Planning and Zoning Board

CASE NUMBER: Z17-002 (PLN2016-00885)

REQUEST: Rezone from AG to HI-PAD AF (20± acres); and rezone

PURPOSE: This request will allow for the expansion of an industrial

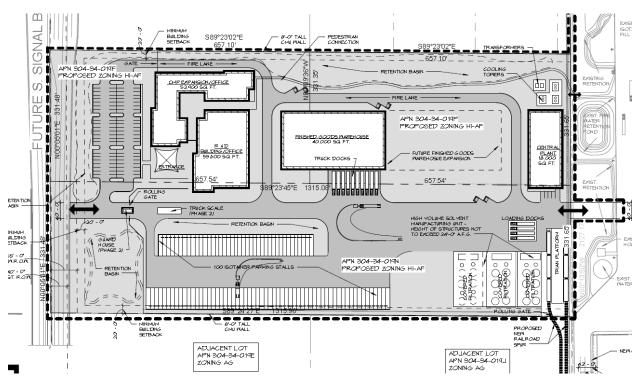
Staff has no concerns with the site plan as proposed. There are, however, a couple of site issues that do need to be resolved with this development.

Two issues relate to development of the street network. Normally, the City codes require the immediate dedication and improvement of the adjacent section line road, Signal Butte in this case. However, none of this street exists in this area. Plus, with the planned expansion of State Route 24, at least some of the Signal Butte right-of-way will be part of the ADOT right-of-way. Because of these issues the City would prefer to delay the dedication of this right-of-way and construction of the roadway until an appropriate time in the future when the final right-of-way needs are determined and there is a need to build more of the roadway. The details and timing of this are to be worked out in a Development Agreement to be approved by Council prior to the approval of the rezoning.

An associated street network need has to do with the three lots to the north of the proposed Fuji west expansion area (shown as lots on the site plan with APNs 304-34-019Q, 019R, and 019S. These lots are currently land locked. Their only option for access is for a street to be constructed centered on the property line on the north side of the Fuji expansion area (APN 304-34-019F). The street may need to jog south before connecting to Signal Butte due to the approach to State Route 24. The City's street system normally requires a street in this location and the Zoning Ordinance does not allow for creation or development of landlocked parcels. When a final site plan is developed for the northern portion of the Fuji property it will need to include land for this right-of-way extending east to include a cul-de-sac centered on the point where parcels 304-34-019F, 019R, and 019S meet. The details and timing of this are to be worked out in a Development Agreement to be approved by Council prior to the approval of the rezoning (see condition #9).

The final issue is the provision of water and sewer service to the west expansion area. The applicant has provided a letter describing how these services can be provided. The information provided is preliminary but demonstrates their understanding of the situation and commitment to providing the needed service even if it means extending new service lines in their private drive from Pecos (see condition #10).

- 8. Replacing the proposed chain link fencing with a permanent wall consistent in design with the wall proposed for the south property line either with the development of Phase 2 of the expansion area or the construction of Signal Butte Road, whichever occurs first.

- 9. Execution of a Development Agreement including but not limited to provisions for the dedication of all right-of-way and construction of roads.
- Each phase of development must comply with the City's water and sewer requirements.
